CHUCK E. CHEESE

City of Aurora Building Division

Project: **Chuck E. Cheese**

Permit: **19-1625136**

Interior Details

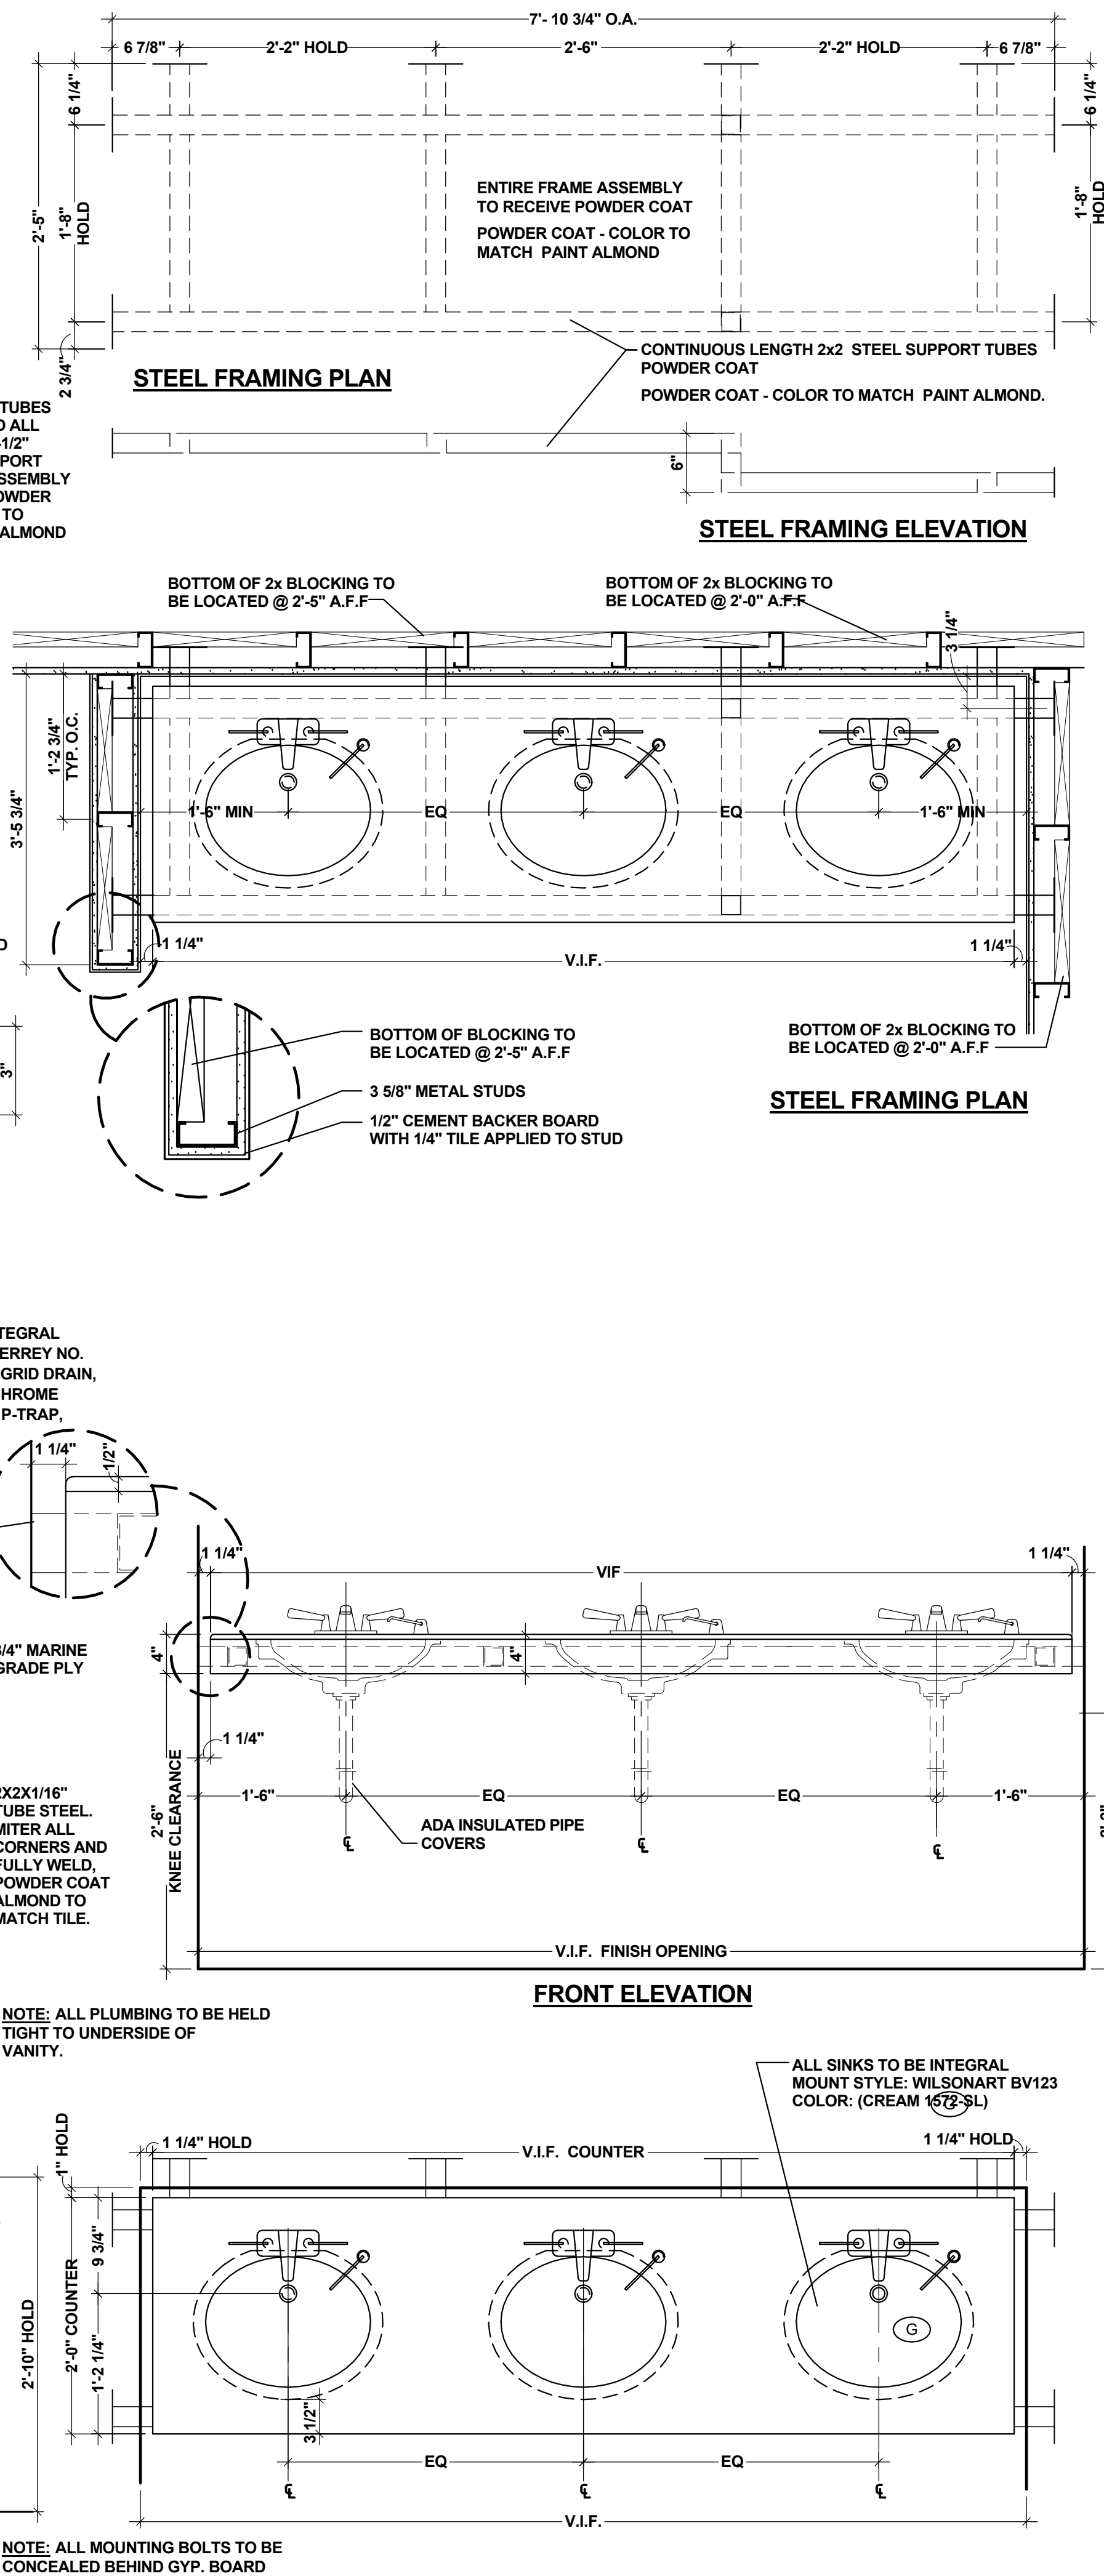
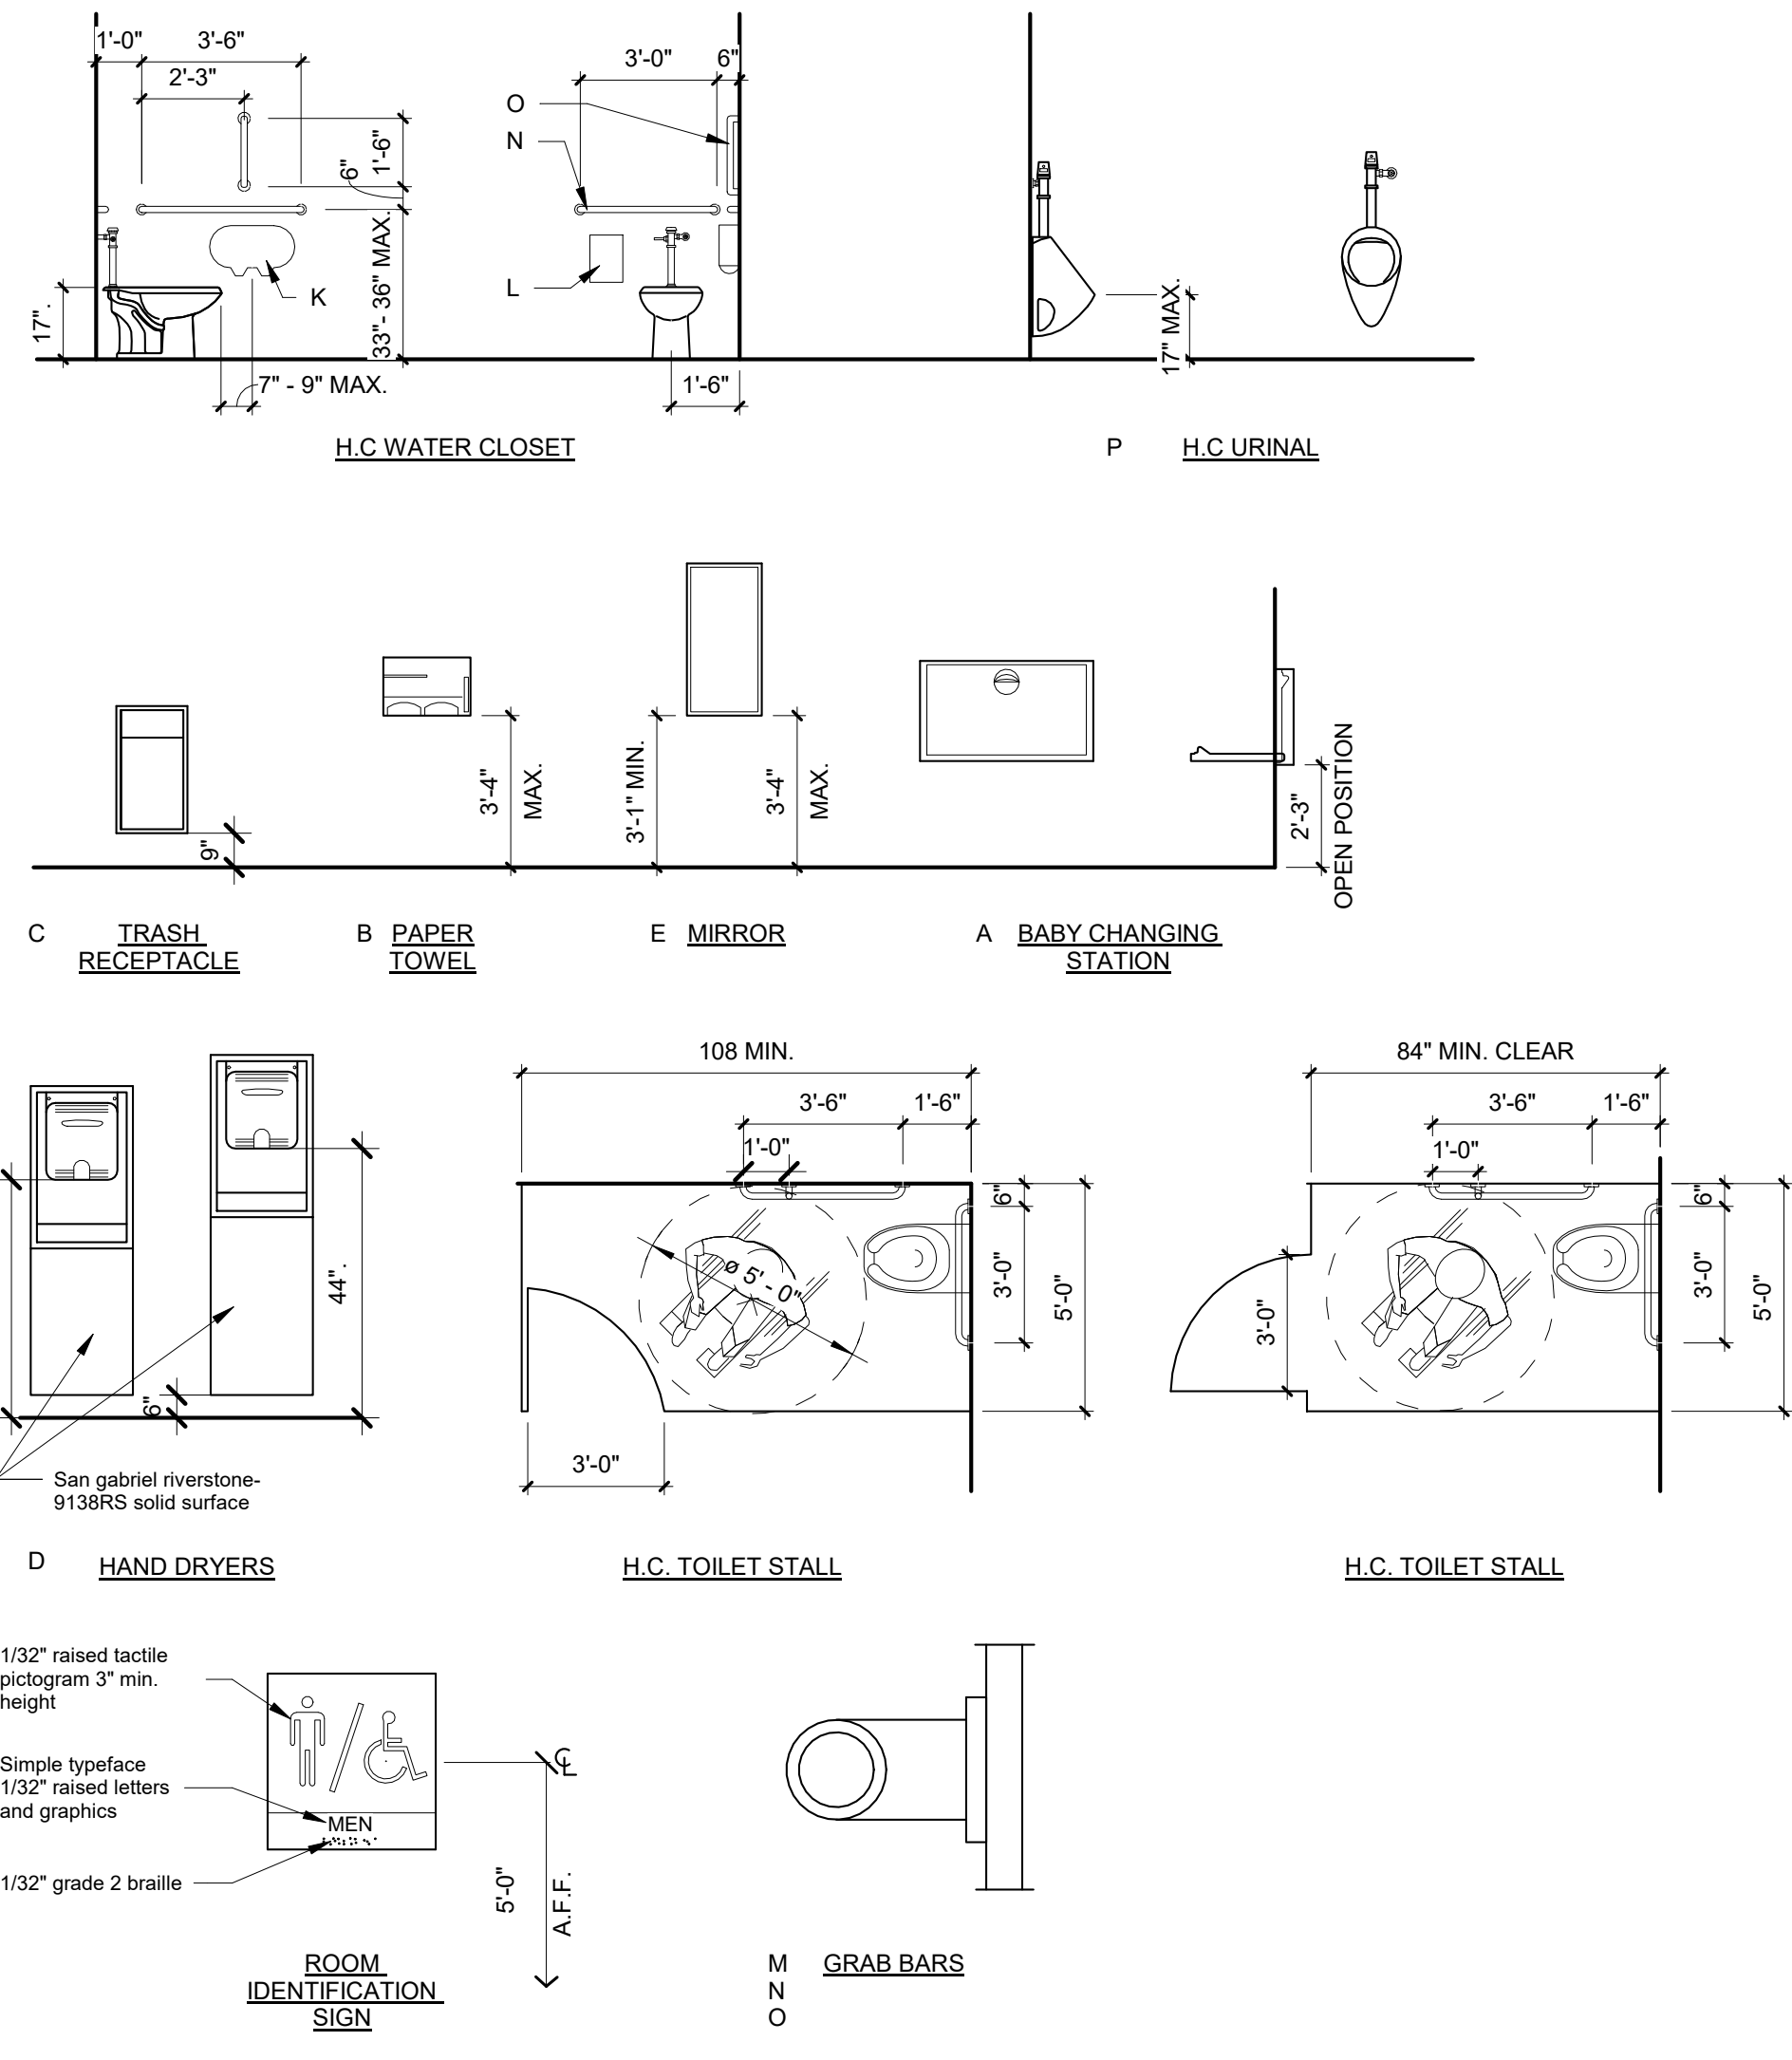
This plan was reviewed for adopted codes and **NOT** for compliance with **ADA** or **FHA** accessibility requirements. Contact 800-949-4232 (**ADA**) and 303-894-7822 x 325 (**FHA**) for federal accessibility requirements that apply to your project.

POWER FLOOR PLAN

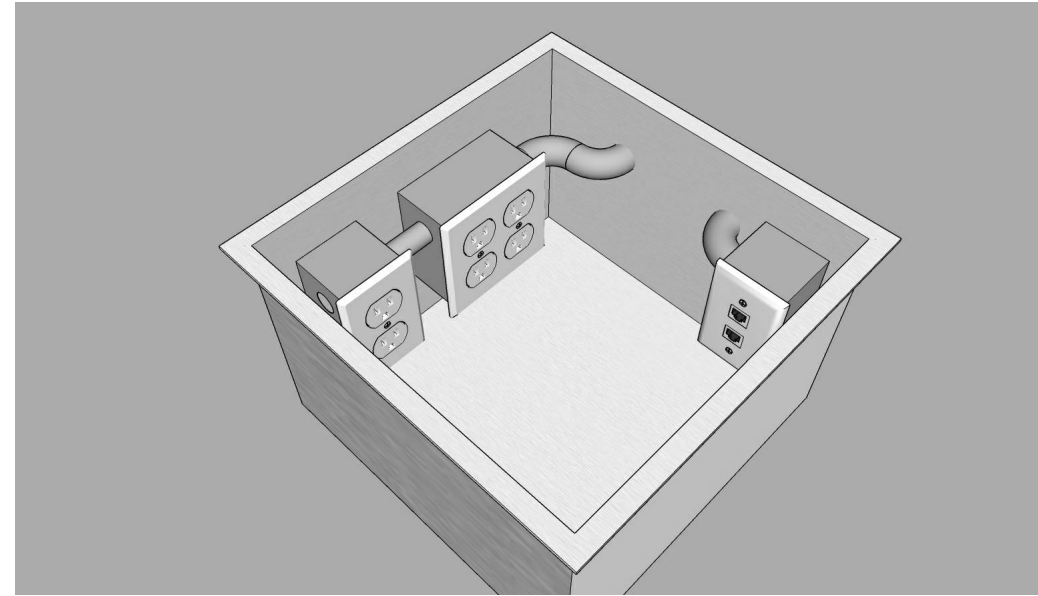
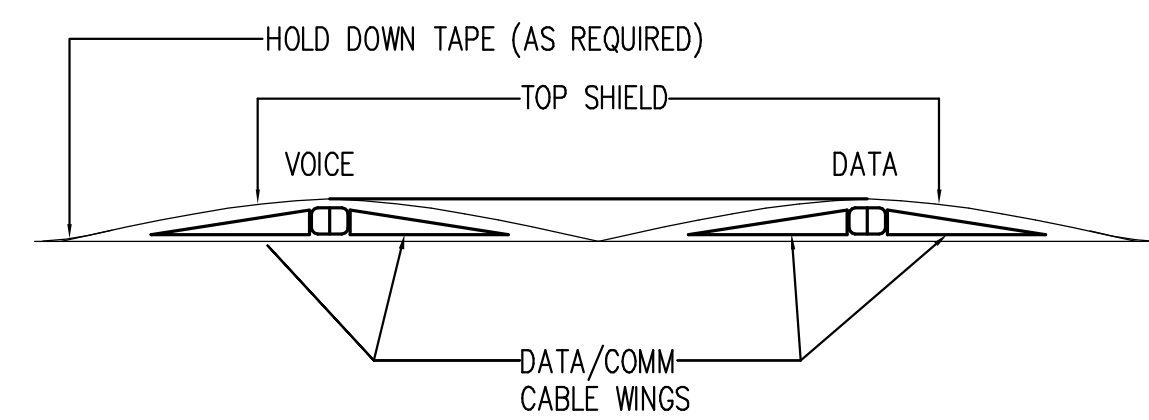
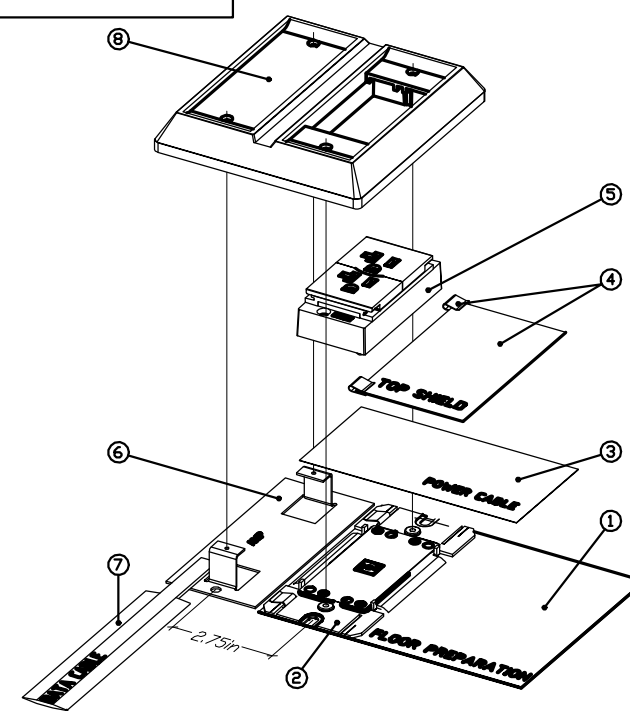
Every circuit and circuit modification shall be legibly identified as to its clear, evident and specific purpose or use. The identification shall include an approved degree of detail that allows each circuit to be distinguished from all others. 2017 NEC 408.4

4 POWER CABLE DIRECTIONAL DETAIL

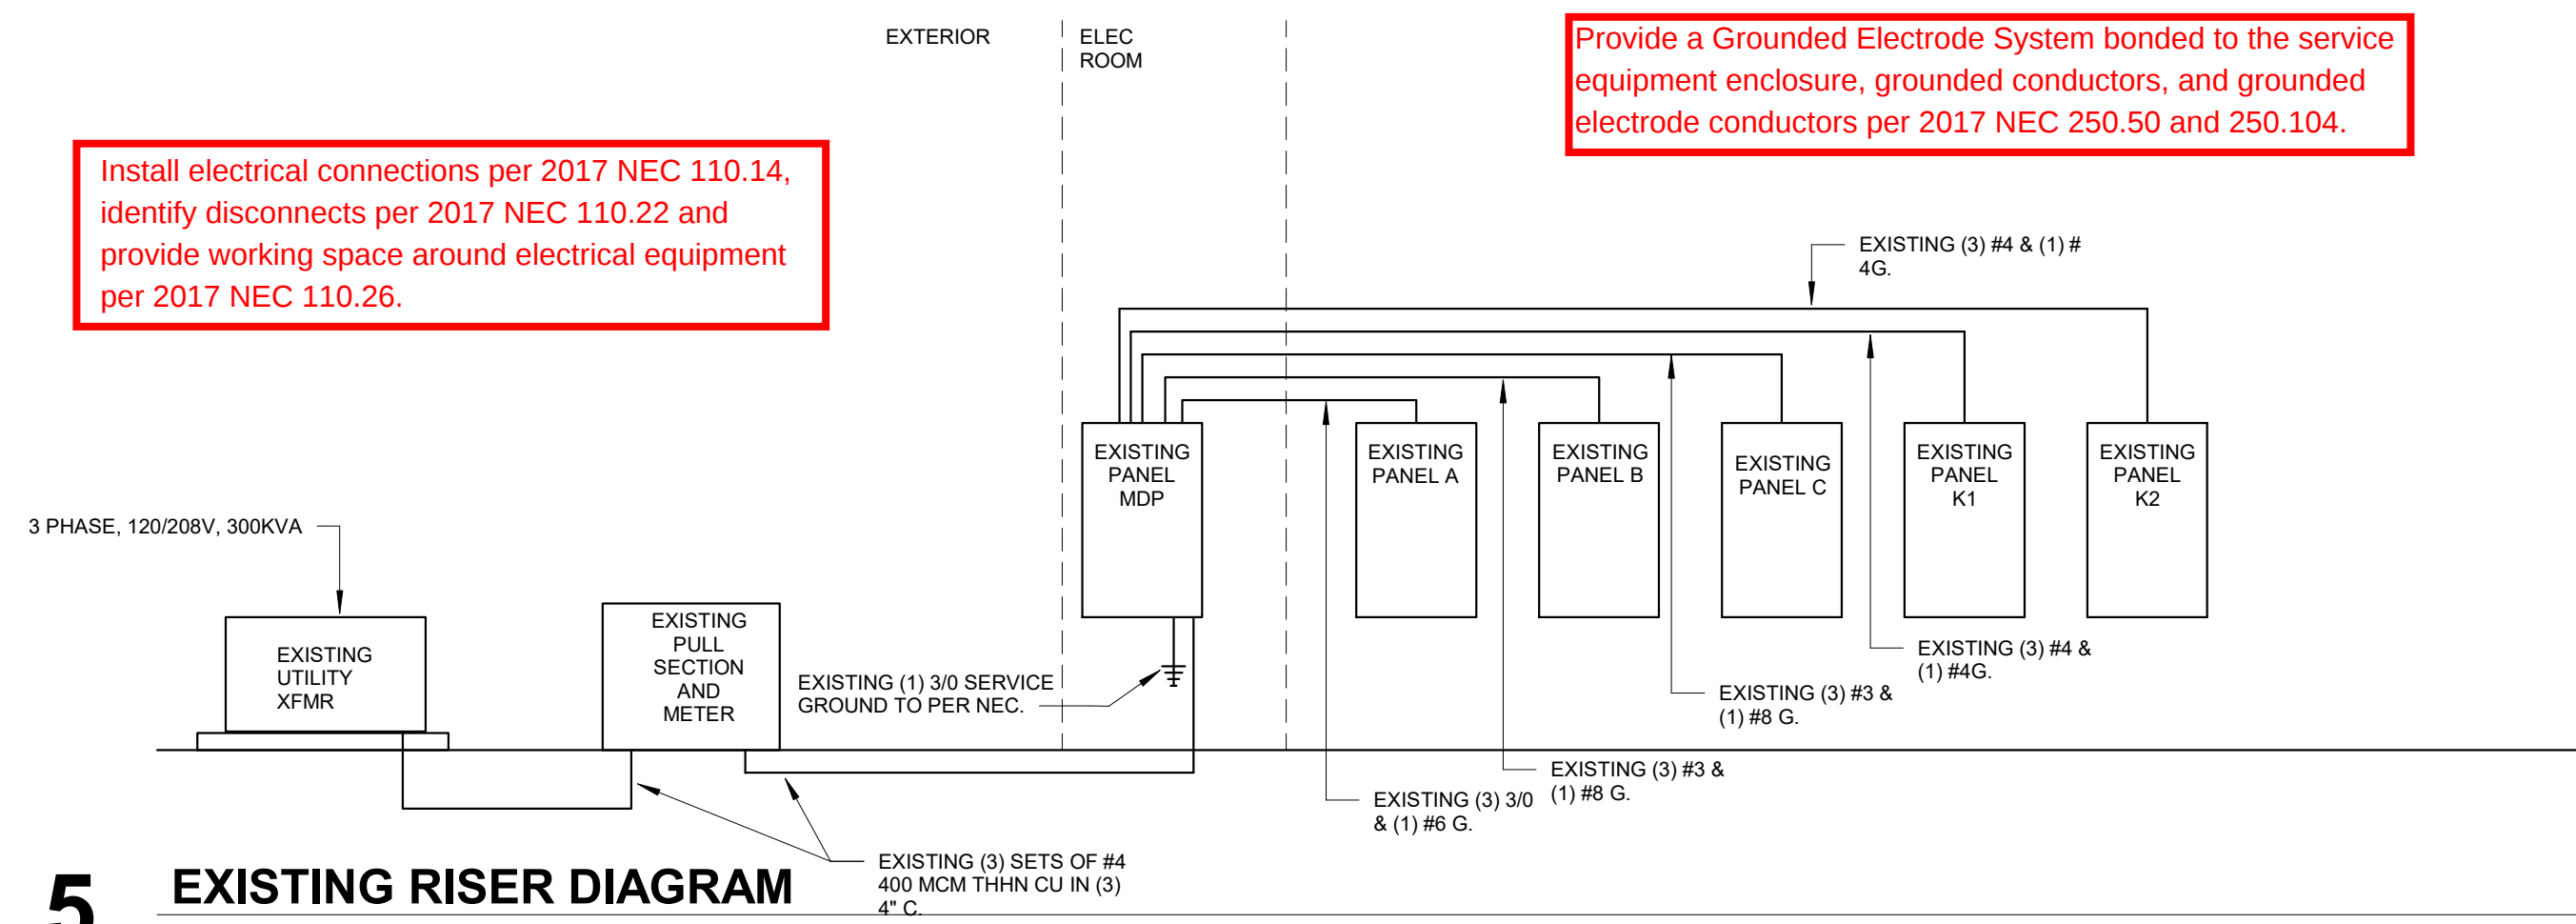
Install electrical connections per 2017 NEC 110.14, identify disconnects per 2017 NEC 110.22 and provide working space around electrical equipment per 2017 NEC 110.26.

Provide a Grounded Electrode System bonded to the service equipment enclosure, grounded conductors, and grounded electrode conductors per 2017 NEC 250.50 and 250.104.

Service Equipment shall be permanently and legibly marked to show the available fault current and date the calculation was performed. 2017 NEC 110.24(A)(B).
